Product Change Notice (PCN)

PCN Number: **PCN-0450656R-01**

Product(s) Affected: *PJ-018*

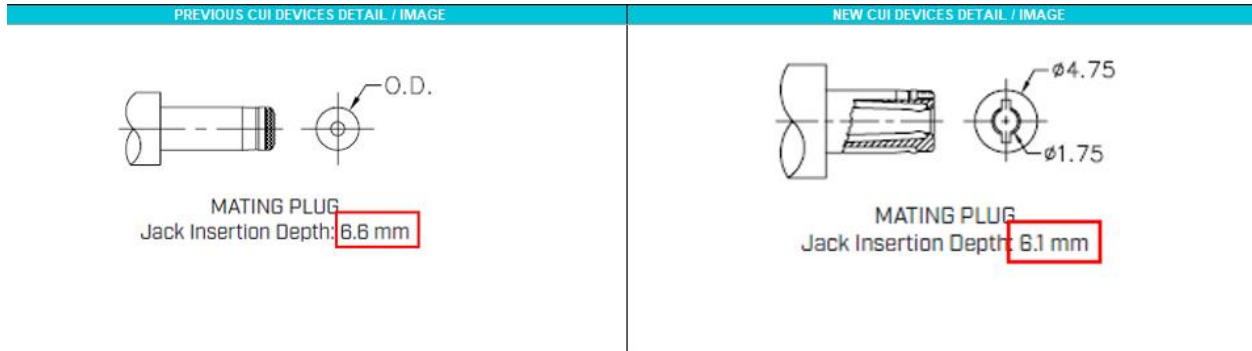
Description of Change: *Minor Housing and footprint differences. Material Change on the housing and terminals. See image Below*

MATERIAL	PLATING
center pin	copper	nickel
terminal 1	brass	tin
terminal 2	copper alloy	tin
terminal 3	brass	tin
plastic	PBT

SOLDERABILITY

parameter	conditions/description	min	typ	max	units
wave soldering	dipped in solder pot for 5 +0.5 seconds	255	260	265	°C

DESCRIPTION	MATERIAL	PLATING/COLOR
center pin	brass	CuSnNi
terminal 1	brass t=0.4	silver
terminal 2	phosphor bronze t=0.25	silver
terminal 3	brass t=0.4	silver
housing	PA10T (UL94V-0)	black

SOLDERABILITY

parameter	conditions/description	min	typ	max	units
wave soldering	dipped in solder pot for 4-8 seconds		250		°C
